Statement of Response to An Bord Pleanála's Notice of Pre-Application Consultation Opinion

Strategic Housing
Development at Rosshill,
Galway

Project Title: **Strategic Housing Development at Rosshill, Galway**

Plate 2-2: Apartment Building (GF) and Car Parking – extract of drawing 20175-3200

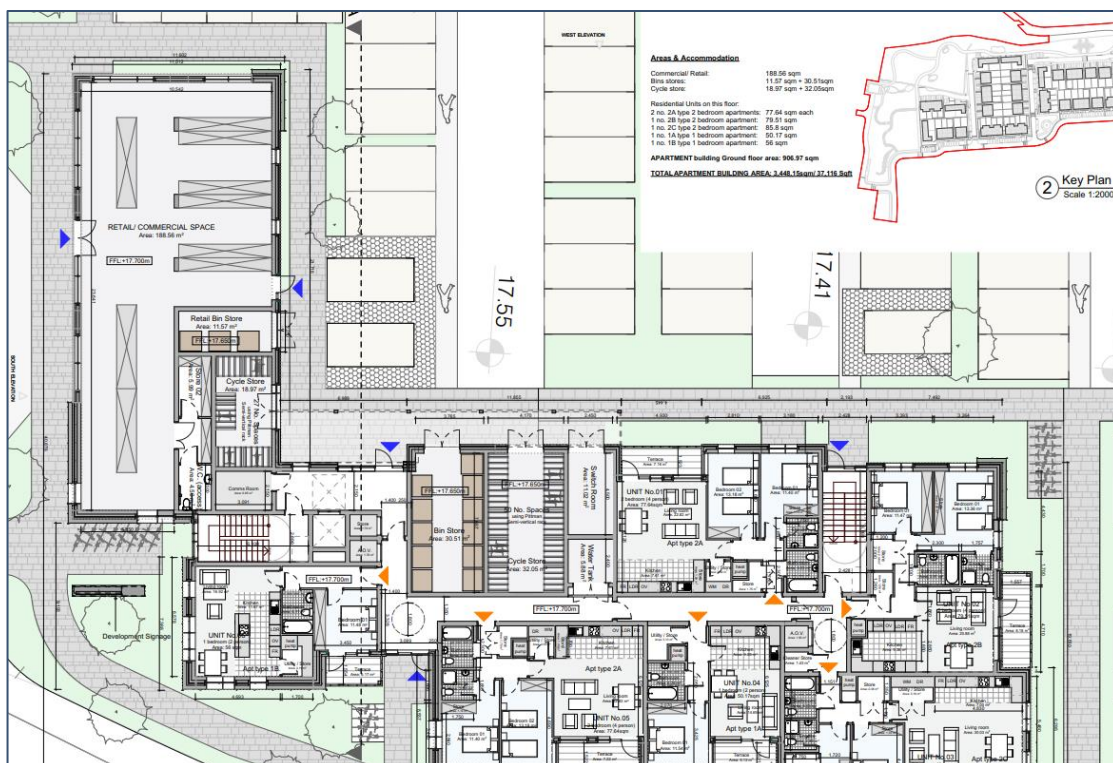
- a) *Provide further justification in relation to the location of the carpark adjoining the rear of the apartment building, the absence of any designated communal open space and the residential amenity of those future occupants of the ground floor units.*

Soft landscaping exists between the building and the car parking area, with this being increased from that shown to the Board at Stage 2 of the SHD process. This additional space has resulted in the loss of 2 no. parking spaces in this location however it affords the main entrance to the apartment building and in particular Apartment no. 1 at ground floor level a more pleasant view westwards.

The car parking serving the apartment building has been positioned to provide convenient and secure car parking for residents (overlooked) and allows for the building to be positioned close to the boundary with Rosshill Stud Farm Road which creates a strong frontage and helps create a sense of arrival into the development. The provision of car parking in close proximity to the associated apartments is advocated in Quality Housing for Sustainable Communities (DoEHLG, 2007) and Design Standards for New Apartments (DoHLGH, 2020).

Plate 2-10: Revised Location of Pumping Station (As Lodged) – extract of drawing 20175-3004

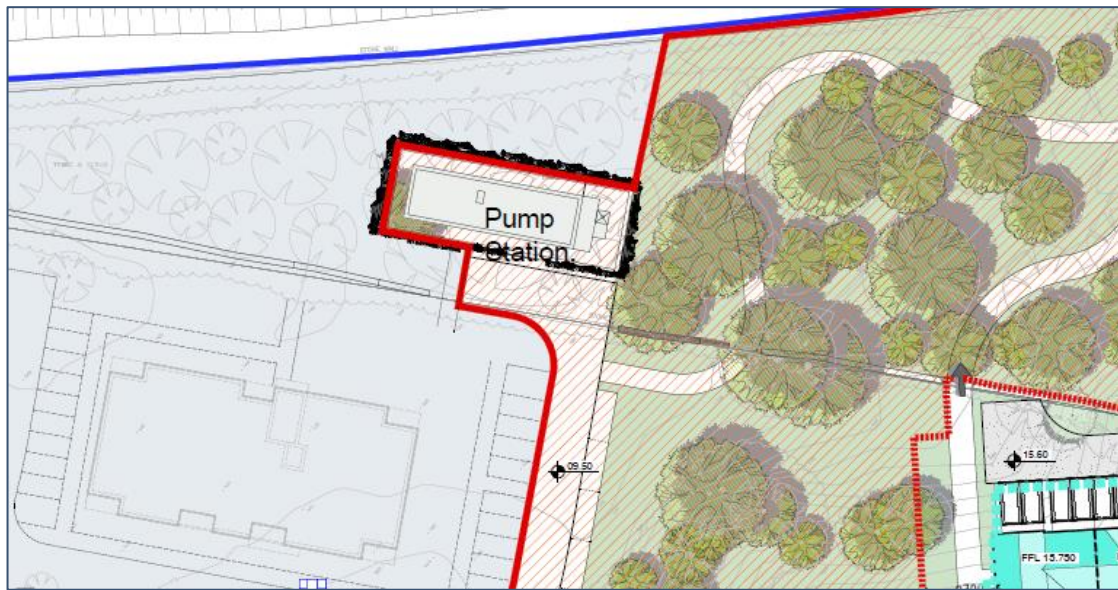
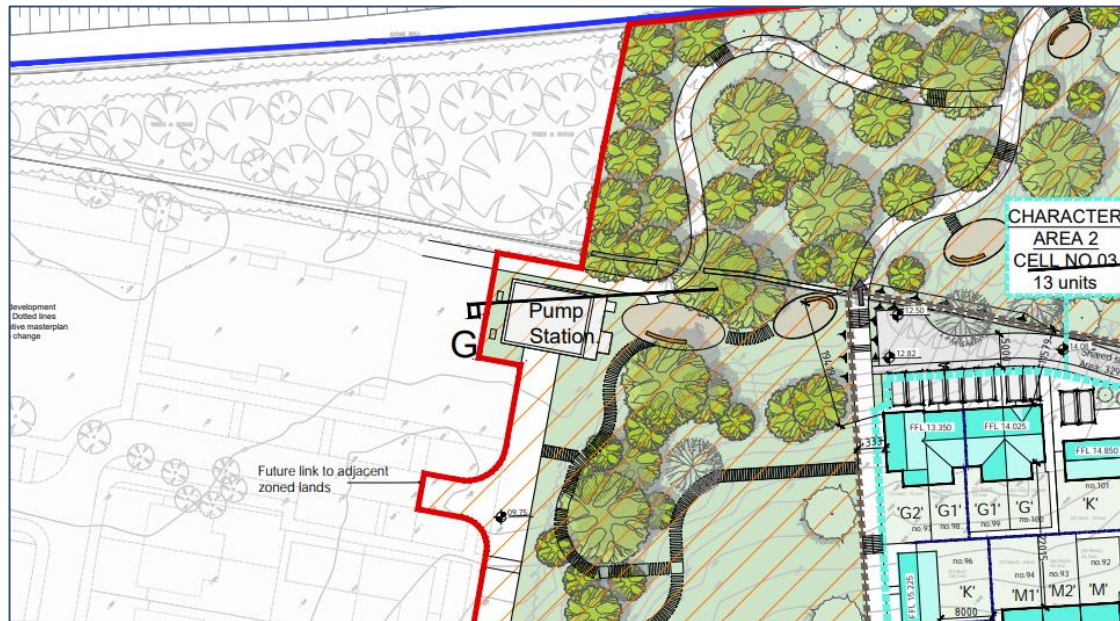
- c) *Provide further justification in relation to location of the pumping station. This further justification should address, inter alia, the options considered which would minimise any ecological impact on the site and the surrounding area.*

During discussions at the tripartite meeting both the Inspector and members of the Council considered this positioning could be reconsidered with a view to maintaining trees where feasible and preserve the character of the site. It is acknowledged that a Development Plan objective of the site is to “*have regard to the sylvan character of the site...*”.

Following discussion with the project engineers, landscape architect and arboriculturist and ecology team, the pumping station was pulled forward of the tree group and the existing stone wall so both remain untouched in the final submitted layout. Ecologically, this design response means the trees, scrub and wall retained will in turn maintain their existing connectivity with the woodland further west. This would result in less disturbance to the woodland area overall which is considered a positive design response.

The revised location avoids the tree group entirely and stone wall, while still achieving the necessary gradients for engineering requirements. The pumping station as proposed will take wastewater via a rising main to discharge to the existing Irish Water (IW) pumping station located at Merlin Park.

Plate 2-12: Attachment 01 from GCC

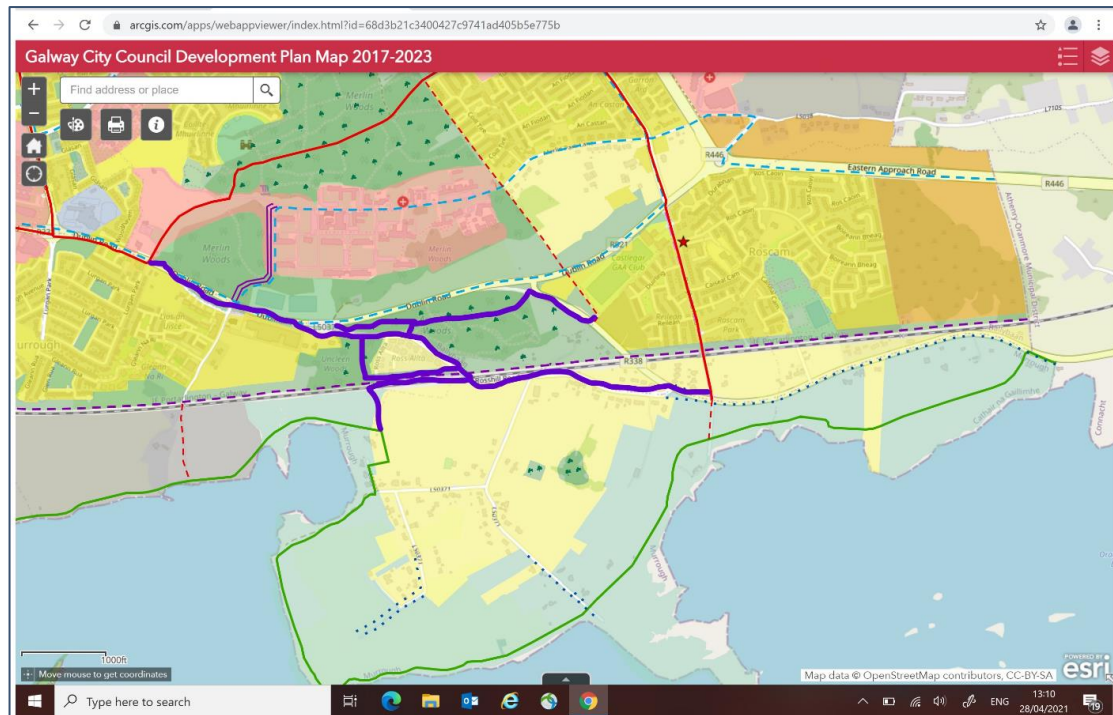
2. Prior to the lodgement of any application the prospective applicant should seek to ascertain what, if any, special contributions, the planning authority may seek at application stage (noting the contents of the report from the Parks Section under 'Appendix 2 Opinions from other Sections of the City Council' of the Planning Authority) and indicate at application stage if

The purple line indicators in Plate 2-12 above reflects an ambition to connect residents of the Rosshill SHD site via an off road network to Aunteen and Uncleen's Woods off Rosshill Road, and greenway networks at Merlin Woods and the Coastal Route. It is noted that the application site does not extend as far east or west as shown above. The application has made provision for increased pedestrian connectivity around the site onto Rosshill Stud Farm Road and Rosshill Road (refer to Tobin drawing 10690-2109 rev P03), to link with the existing network in place. The proposals will therefore positively contribute to the ambitions of the Council.

Plate 2-14: Indicative Phasing – extract of drawing 20175-3028

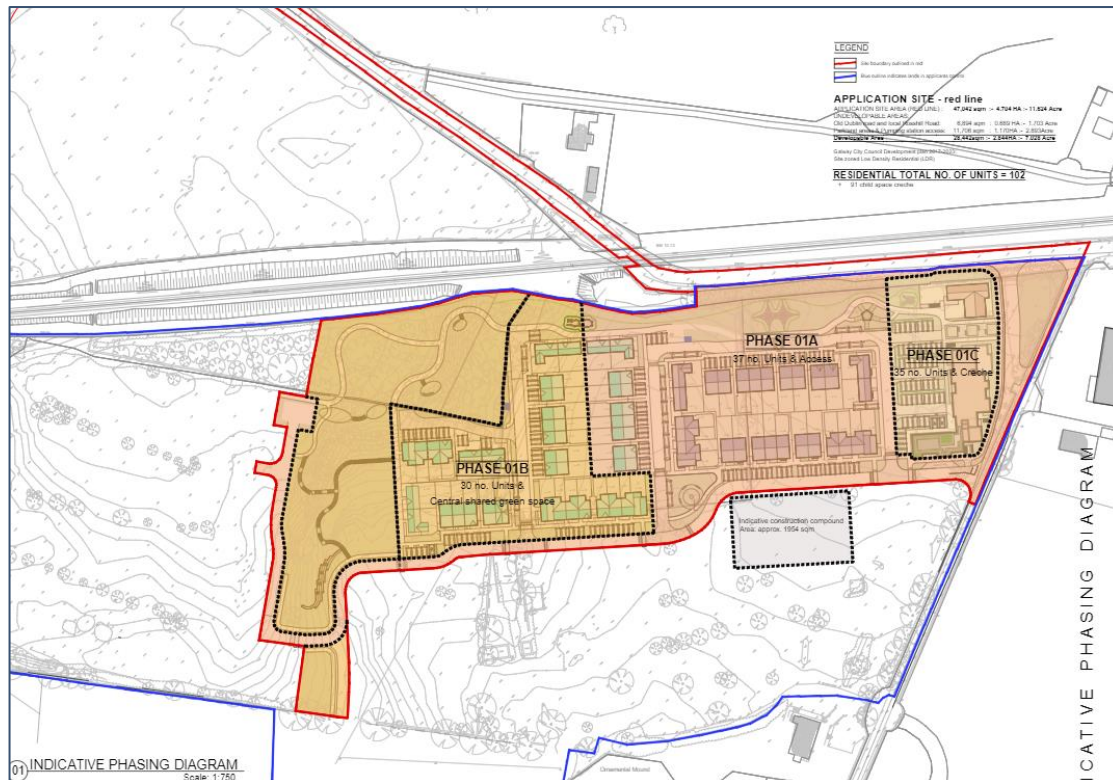
5. A detailed phasing plan.

The proposed phasing of the development enables this as follows:

- Phase 1A: This will consist of the construction of the pumping station, associated services and access roads including road widening of existing Rosshill Road. Construction will also include the most accessible houses for occupation consisting of 37 units.
- Phase 1B: Construction of this phase will overlap with Phase 1A and allow a practical continuation of occupation of homes consisting of 30 units and opening up of the principle amenity space in the development for use by the residents.
- Phase 1C: This will consist of the construction of the large apartment block which will be the slowest to finish and occupy. In conjunction with this the construction of the creche will be completed and made available to the residents of the development.
